**Oconee Nuclear Station Corrective Actions
for Generic Letter 2004-02**

Figure 5 Composite Drawing of Sump Structures

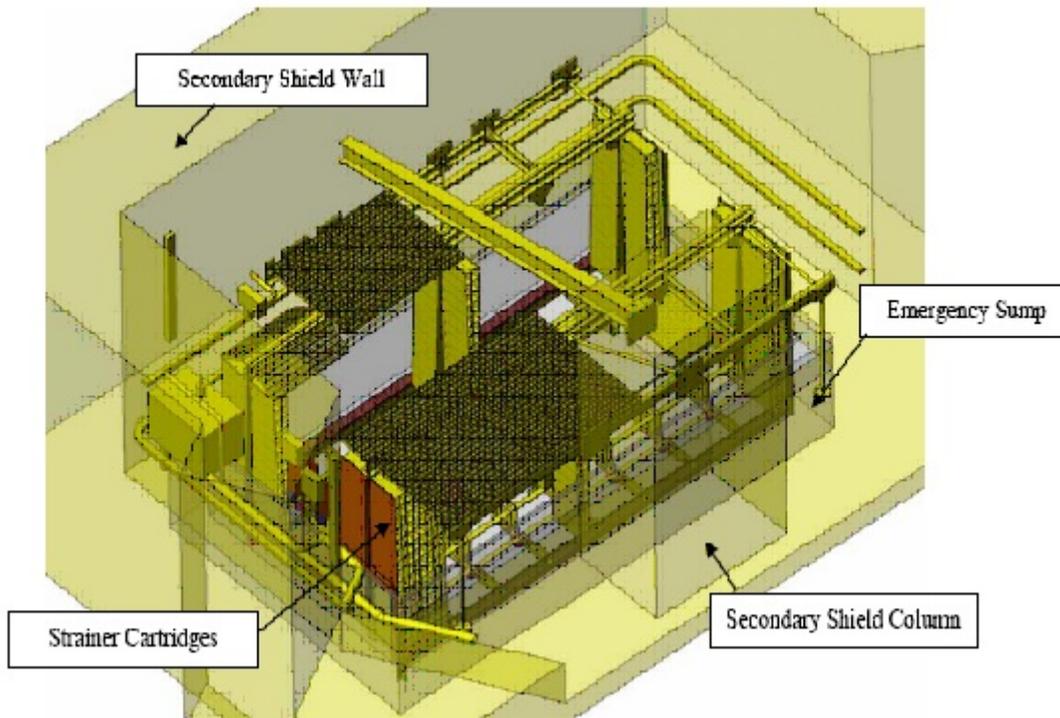
The RBES strainers for the ONS Units 1, 2 and 3 have been enlarged as part of the resolution of GL 2004-02. The RBES strainers for each unit are in the RBES enclosure located in the basement floor of the Reactor Building (elevation 774 ft.). The strainers are surrounded on three sides by a 4 ft wall and partially protected on the other side by a 4'x6' column. The new, larger RBES strainers extend above the floor level by approximately 3.5 feet. See Figure 5 for a representative composite drawing.

The licensee issued Engineering Design Change Packages for the RBES strainer replacements at ONS. The licensee evaluated the safety impacts of the packages by screening pursuant to 10 CFR 50.59, considering the Updated Final Safety Analysis Report, and concluded that the design change does not adversely impact sump design functions. The licensee concluded that the structural calculations performed as part of the Engineering Design Change Package have shown satisfactory results.
